PROCEDURE NO. 4.3.3

QUALITY CONTROL DIVISION
WELDING PROCEDURE REVIEW

CLIENT Commonwealth Edison Company STATION Braidwood UNIT 1&2
CONTRACTOR L. K. Comstock & Co. PROJECT NO. 4683-05

4.3.3
WELDING PROCEDURE
FOR
STRUCTURAL ATTACHMENTS
(7018)

ATTACHMENT 'A'

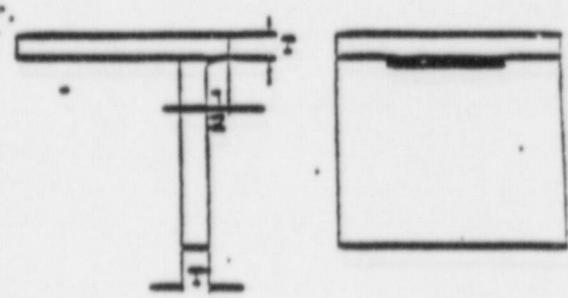
ITEM NO.	STATUS	GUIDELINE IDENT.	PROCEDURE NO.	REV.	DATE	WELDING PROCESS	P-NOS	THICKNESS RANGE QUALIFIED, INCHES
1.	2	--	4.3.3	D	8/29/84	SMAW	C.S.	Qualified & Prequalified
Comments: <p>A) On Attachment 'A' state "single", under "Single or multiple pass."</p> <p>B) It appears that Attachment 'K' is for the welding of a partial penetration groove weld. If this is so, then delete the Note referring to backgouging of the weld.</p> <p>C) On Attachment 'F' the volts can only be from 19 to 26 volts since the procedure was only qualified at 23 volts.</p> <p>D) On Attachment 'N' for the overhead position the volts shall be "21-29 volts", "2 - 29 volts" is unacceptable.</p> <p style="text-align: center;">FOR INFORMATION ONLY</p>
